Subject: Submission comments re: Application number DA2020/1043

As direct neighbours to Number 45, we would like to raise some points about this development application:

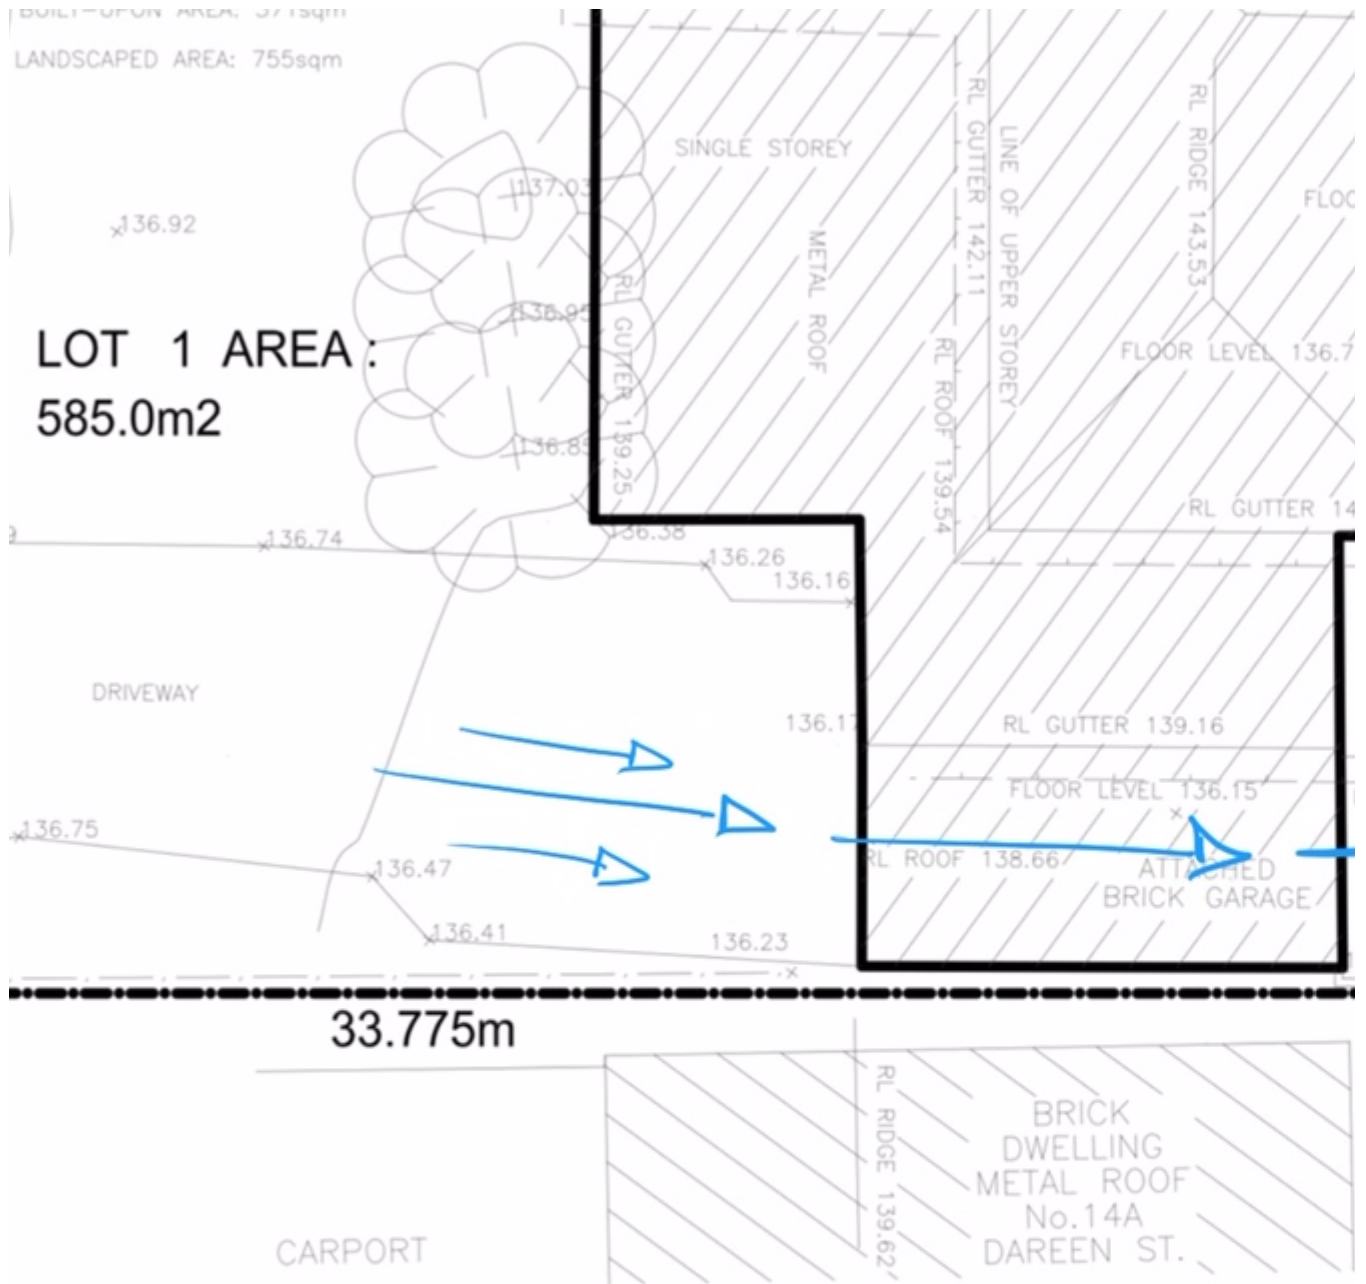
- 1) Our property currently receives a lot of water overflow from number 45 during heavy rain. Please note that we, along with our back neighbour at [14A Dareen Street](#), have recently consulted with NB council's James Leigh, Manager, Stormwater & Floodplain Engineering, about excess water drainage onto our Lot.
- 2) Water currently travels down the hard surfaces of the common driveway from Dareen Street through the concrete driveway to the back corner of Lot 1 and then into our Lot.
- 3) We welcome the installation of storm water drainage along the full boundary of our property - from the back corner of the proposed Lot 1 and along the boundary of proposed Lot 2.
- 4) In the subdivision/demolition plan the 900mm stormwater easement does not appear to extend to the back boundary of Lot 2 Area. Why is this?

WILL NEW EASE
COLLECT WATER
INTO OUR YARD FR
BACK CORN
